Project		Design and Construction of Civil and Buildings Works including Testing and Commissioning on Design-Build Lump Sum Price basis for Double Line High Speed Railway for Mumbai Underground Station, Cut & Cover Tunnel and Shaft -1 from MAHSR Km. -0.255 to Km. 0.775 at Bandra-Kurla Complex in the State of Maharashtra for the Project for Construction of Mumbai-Ahmedabad High Speed Rail			
Package No.		MAHSR - C - 1

Response to Bid Queries (Set-3) - 30.04.2020					
S No	Part & Section Reference	Page No / Clause No.	Provision as per Bidding Documents / Subject / Title / Item as mentioned by the Bidder	Bidder Query	Employer's Response
1	Part-1, Section-II, BDS (Vol.1 of 2)	BDS Clause No. ITB-24.1 Page 3 of 34 (16/632)	Last Date for Submission of Tender: The deadline for Bid submission is: Date : 19.03.2020 Time : 15:00 hrs	The Bidder to collect various information for planning for project logistics, material availability and so on, prior to preparation of bid, which required substantial time. Further Bidder requires to depute designer and MEP specialist agency to perform the pretender design works which required a substantial time for competitive bidding. <b>In view of the above bid

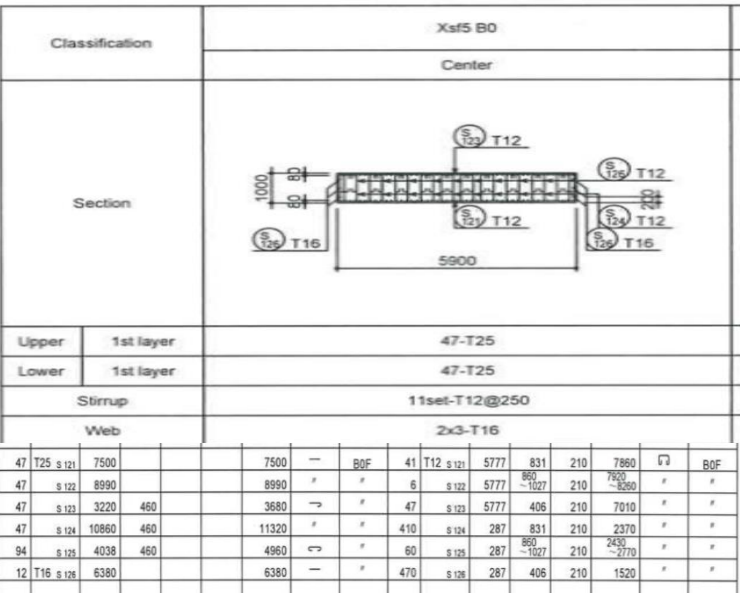
20	Section VI-4, Architectural Drawings	B0-JIC-C14-DRW-S01-STA-NTU-04001-000	Detail Section-1	Detail section 1 indicates semispherical Decorative cast aluminum ,where as Division 05010 page no. 46 of 60 depicts these decorative elements in the form of cone of 500 mm dia and 150 mm height. Please provide the detail drawing of these decorative cast aluminum along with its fixing details on concrete panels.	Refer BD-JIC-C14-DRW-S01-STA-NTU-4001 to 4003 & 06111. The Contractor shall develop during detailed design for the approval of the Engineer.
21	Section VI-4, Architectural Drawings	B0-JIC-C14-DRW-S01-STA-NTU-04001-000	Detail Section-1	Please provide top and bottom fixing details for the column structural mild steel	The Contractor shall develop during detailed design for the approval of the Engineer.
22	Section VI-4, Architectural Drawings		General	The details for at grade landscape is not shown. Please provide details.	The scope of Landscaping is shown in BD-JIC-C14-DRW-S01-STA-NTU-01101, 02108, 02201, 02202, 02203, 02204, 04011 and 06104.  The Contractor shall develop during detailed design for the approval of the Engineer.

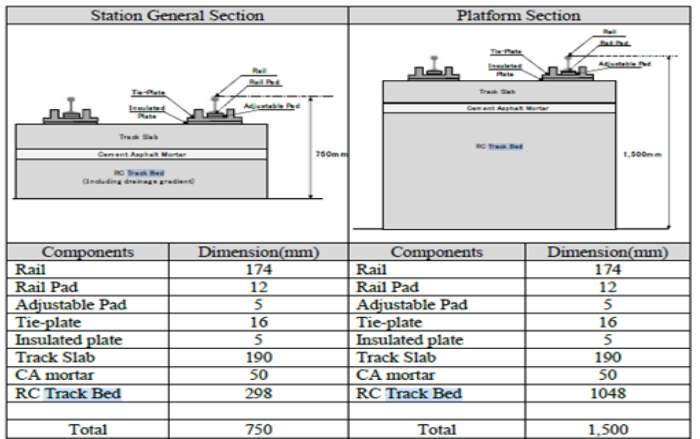
S No	Part & Section Reference	Page No / Clause No.	Provision as per Bidding Documents / Subject / Title / Item as mentioned by the Bidder	Bidder Query	Employer's Response						
62	Volume – 2 of 2, Section VI-2, Employer's Requirement (Design Requirement and criteria) Division 05040	Clause 17.5 Page 34 of 58 Electrical		Please confirm the fault level of DSS & S&T UPS for earth mat design	Refer Sub-Clause 4.4.9 of DRC 05040. The Contractor shall interface with E-1 contractor during the detailed design.						
63	BD-JIC-C14-DRW-S01-STA-NTU-022(01-41)	Architecture		Wall material (AAC block work or RCC) of Staircase enclosure walls at all levels is not consistent in Architecture and structure drawings. Hence, we are considering as RCC wall for the same Please confirm.	Refer Note-3 of Addendum No. 01, Item No. 38.						
64	BD-JIC-C14-DRW-S01-STA-NTU-02201 & 02203	Architecture		In structure drawings RCC Columns are shown from URF level going up to entry structures' roof level (On grids Y2, Y3, Y5 & Y6) inside the Aesthetical MS tubular columns/ elements. Whereas these columns are not shown in Architecture drawings. Please confirm which drawings to be followed Architectural or Structural drawings.	Refer Note-3 of Addendum No. 01, Item No. 38.						
65	BD-JIC-C14-DRW-S01-STA-NTU-021(01-03)	Architecture		Grid Dimensions of Elevation is not matching with Floor Plans. Hence, we are following floor plans. Please confirm.	The grid dimensions mentioned in the Floor plans shall be followed.						
66	Volume 2 of 2, Section VI-4 (DRAWINGS). BD-JIC-C14-DRW-S01-STA-NTU-02112-000 & 02110-000	MUMBAI STATION B1 FLOOR ENLARGED PLAN-2, ROOF, MF, URF ENLARGED PLANS	Provision of Spiral Staircase No. M5,M6,M7 & M8	Kindly provide Spiral Staircase details. We understand that its construction material is structural steel. Please confirm.	The stairs are only for maintenance personnel. The Contractor shall propose the material and develop the details during detailed design for the approval of the Engineer.						
67	Volume 2 of 2, Section VI-4 (DRAWINGS). BD-JIC-C14-DRW-S01-STA-NTU-02112-000	MUMBAI STATION B1 FLOOR ENLARGED PLAN-2	Provision of Machine hatch	Kindly provide machine hatch size.	Refer Slab Structural Opening Plan (BD-JIC-C14-DRW-S01-STA-NTU-06260 and BD-JIC-C14-DRW-S01-STA-NTU-06267)						
68	Volume 2 of 2, Section VI-4 (DRAWINGS). SD-MTC-D01-TDS-S01-CCT-NTU-20214-001 & SD-MTC-D01-TDS-S01-CCT-NTU-20164-001	RC DETAILS: B1 (SLAB) LVL. SHEET (2 OF 8) and RC DETAILS: CROSS SECTIONS SHEET (3 OF 5)	Provision of Slab Reinforcement.	Mismatch in Slab reinforcement plan and Section drawings

As this mismatch will affect Quantity, Please clarify and confirm the drawing to be followed. Similar mismatch is observed in Cut and Cover portion also.	Top -ve Reinforcement		Plan	Section	Y20 @ 150	Y20 @ 150 and Y20 @ 300 Alternatively	Refer Addendum No. 01, Item No. 41 and Addendum No. 02, Item No. 37.
Top -ve Reinforcement											
Plan	Section										
Y20 @ 150	Y20 @ 150 and Y20 @ 300 Alternatively										
69	Volume 2 of 2, Section VI-4 (DRAWINGS). SD-MTC-D01-TDS-S01-CCT-NTU-20213-001	RC DETAILS: B1 (SLAB) LVL. SHEET (1 OF 8)	Provision of Slab Reinforcement.	Top reinforcement is given as Y20@150+Y16@150. Our understanding is that both above bars are bundled and provided at a spacing of 150 c/c and are curtailed at 3100 from face of the beam. No top reinforcement at mid span. Please confirm.	Refer Addendum No. 01, Item No. 41.						
70	Volume 2 of 2, Section VI-4 (DRAWINGS). BD-JIC-C14-DRW-S01-STA-NTU-07003-000 and 07004-000	MUMBAI STATION ENTRANCE-2 FRAMING PLAN and ELEVATION		1. Member are listed with only outer sizes. Hence, kindly provide member thickness. 2. In plan, all un-named beams are given as SB4 whereas section taken at that location (Section at Y4) are marked as SB2. Please confirm the correctness.	1. Members shown in the drawings are for reference only. The Contractor shall develop during detailed design for the approval of the Engineer. 2. SB4 is correct.
